# 747 NOTICES

This book contains all notices which apply to **747 Flight Crew**.

## Drift Down and Decompression Procedure UP975/UG8/UM688 – Decision Point Change

Figure 1 - Decompression procedure  
UP975/UG8/UM688  
Eastbound

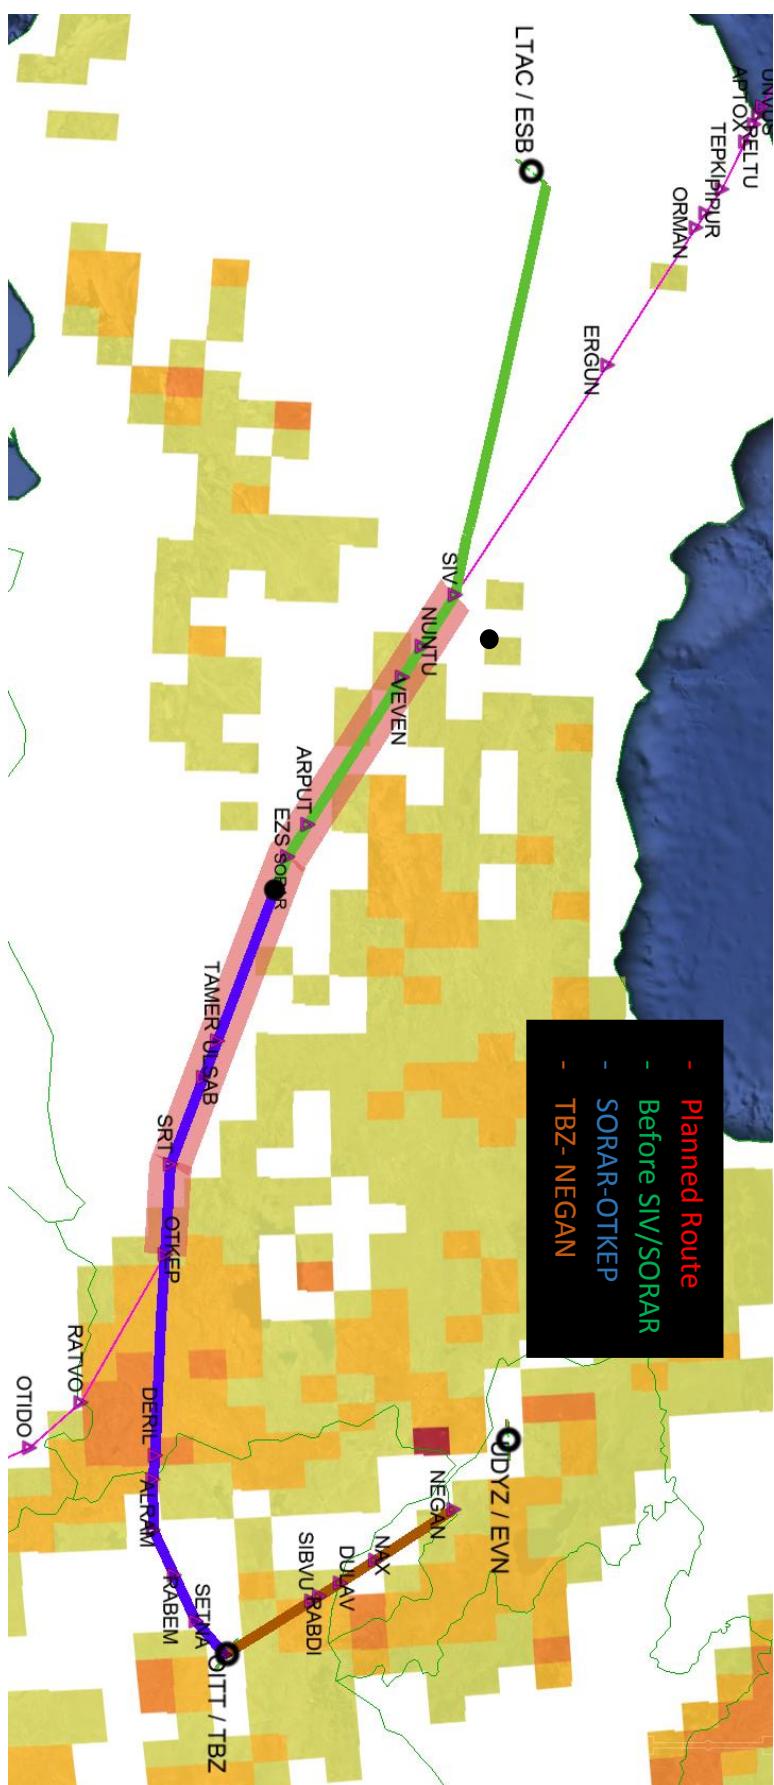
Following crew feedback and a reassessment of the route, the driftdown and decompression procedure for UP975/UG8/UM668 through to Northern Iraq has been adjusted.

| B747-400  | UP975/UG8/UM688 Eastbound |
|---|---------------------------|
| <b>Notes</b> – see figure 1 (new figure).   |                           |

| B747-400  | UP975/UG8/UM688 Eastbound |
|---|---------------------------|
| 1. Before SIVAS/SIV – divert as appropriate <b>OR</b> continue to SIVAS/SIV, turn right onto UL615 and divert to Ankara (LTAC/ESB).   |                           |
| 2. Between SIVAS/SIV and SORAR: turn right and backtrack, offsetting the airway to SIVAS/SIV, turn left onto UL615 and divert to Ankara (LTAC/ESB).   |                           |
| 3. Between SORAR SIVAS/SIV and OTKEP – continue to OTKEP, continue onto UG8 to ALRAM, G208 to UMH, A422 to TBZ and divert to Tabriz (OITT/TBZ). If Tabriz is not available, turn North from TBZ on R661 to DULAV, L125 to NEGAN and divert to Yerevan (UDYZ/EVN). |                           |
| 4. After OTKEP – continue on planned route and divert as appropriate.   |                           |

Figure 1 - KAUS Apron Taxiways

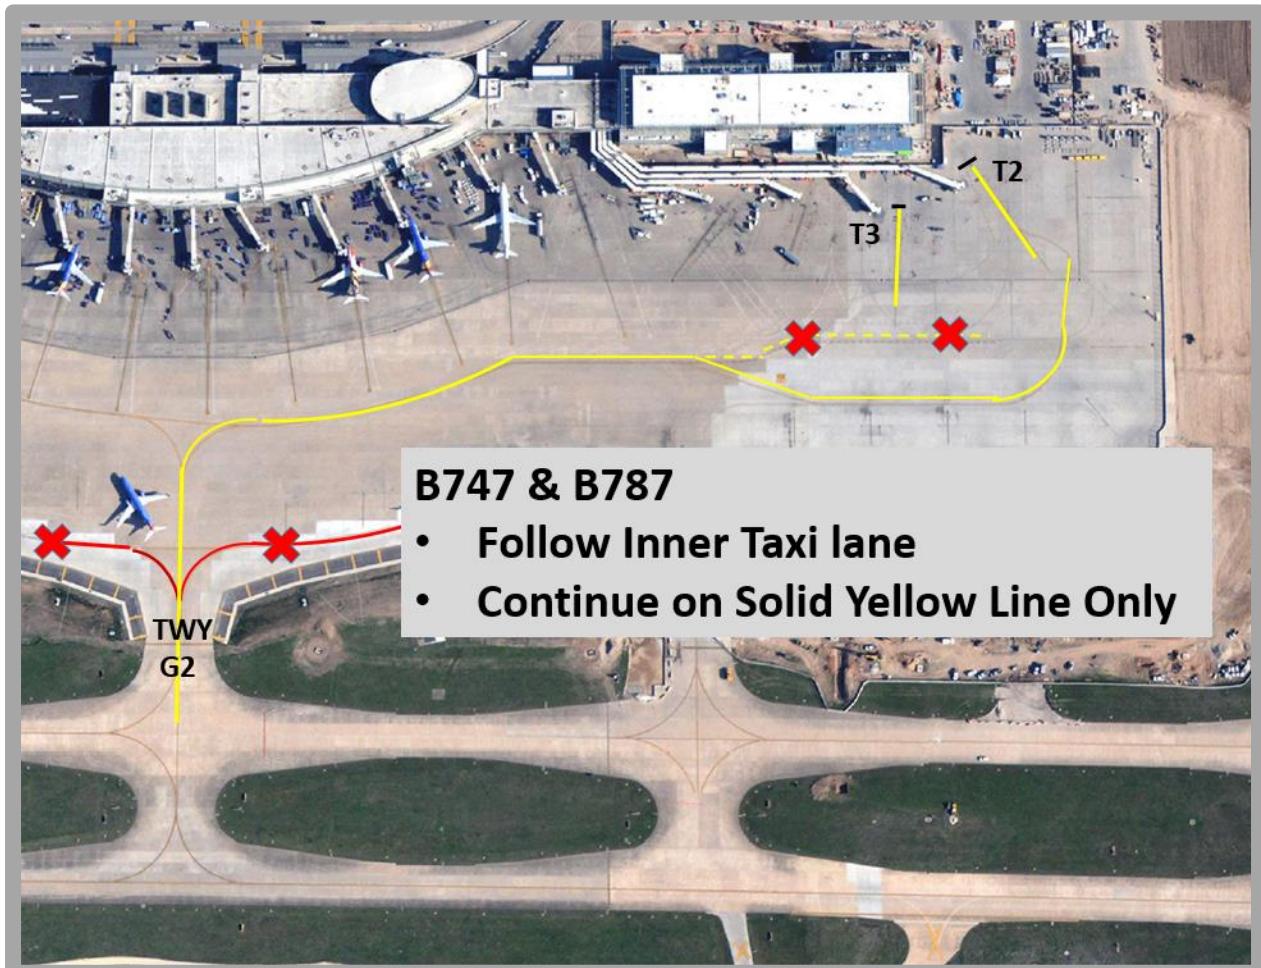
A diagram has been added for visual representation of the apron taxiway restrictions.

- BA normally park on Stand 2. The turn onto this stand is about 110° (slightly back on yourself).
- Usual parking stands are T3 or T2.
- Exercise caution in the ramp area as ramp space is constrained in contrast to the airfield and uncontrolled.
- Exercise extra caution when taxiing and carrying out 90 degree turns due to narrow taxiways.
- Do not accept dashed taxi lines near stands T2-T4. Only use solid taxi lines when taxiing. See Figure 1.
